95.7 PMD to MDI optical specifications for 100GBASE-SR4

95.8.5 Transmitter vertical eye closure (TxVEC)

Figure 95–3—TxVEC conformance test block diagram

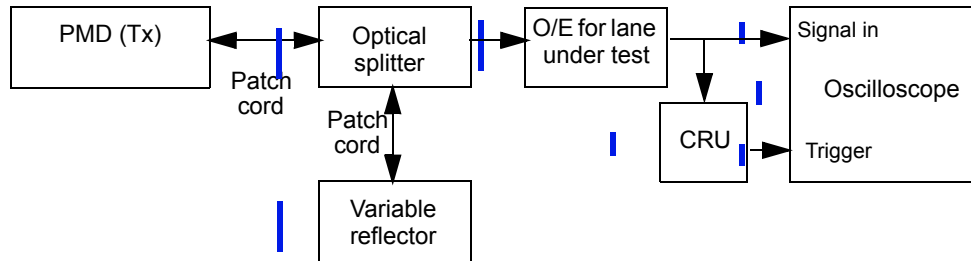
A block diagram for the TxVEC conformance test is shown in Figure 95–3. Other measurement

Each optical lane is tested individually with all other lanes in operation. The optical splitter and variable reflector are adjusted so that each transmitter is tested with an optical return loss of 12 dB.

The combination of the O/E and the oscilloscope used to measure the optical waveform has a fourth-order Bessel-Thomson filter response with a bandwidth of 12.6 GHz. Compensation may be made for any deviation from an ideal fourth-order Bessel-Thomson response.

The clock recovery unit (CRU) has a corner frequency of 10 MHz and a slope of 20 dB/decade.

Figure 95-4—Illustration of the TxVEC measurement

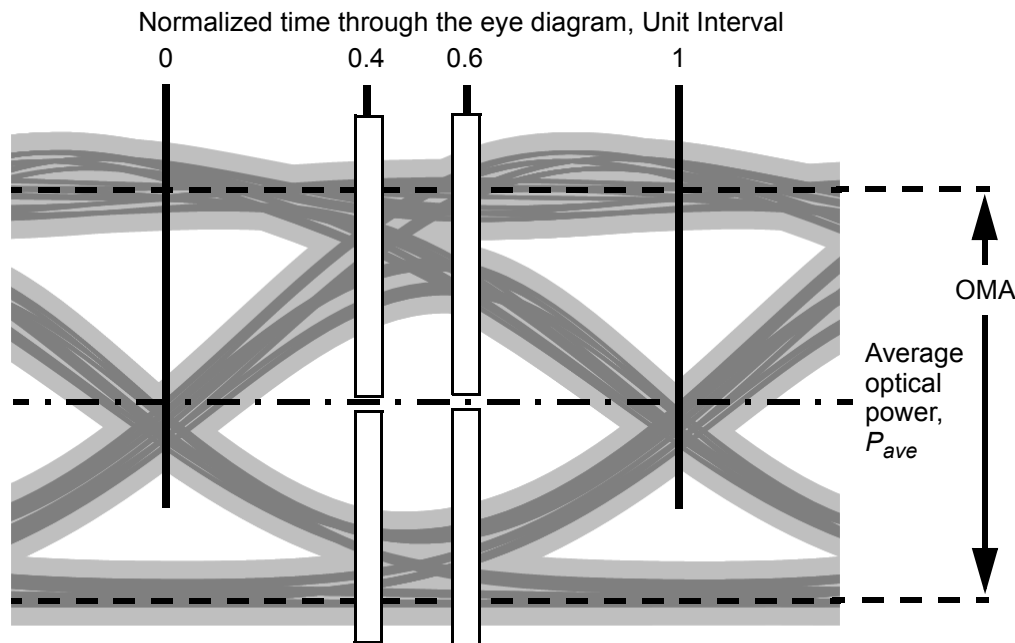
The oscilloscope is set up to accumulate samples of the optical eye diagram for the transmitter under test, as illustrated in Figure 95–4.

The average optical power (P_{ave}) and the crossing points of the eye diagram, and the four vertical histograms used to calculate TxVEC, are measured using Pattern 3 or Pattern 5. The 0 UI and 1 UI crossing points are determined by the time average of the eye diagram crossing points, as measured at P_{ave} , as illustrated in Figure 95–4.

Four vertical histograms are measured through the eye diagram, centered at 0.4 UI and 0.6 UI, and above and below P_{ave} , as illustrated in Figure 95–4.

Each histogram window has a width of 0.04 UI. Each histogram window has an inner height boundary which is set close to P_{ave} (so that no further samples would be captured by moving it closer to P_{ave}), and an

[outer height boundary which is set beyond the outer-most samples of the eye diagram, so that no further samples would be captured by increasing the outer boundary of the histogram.](#)
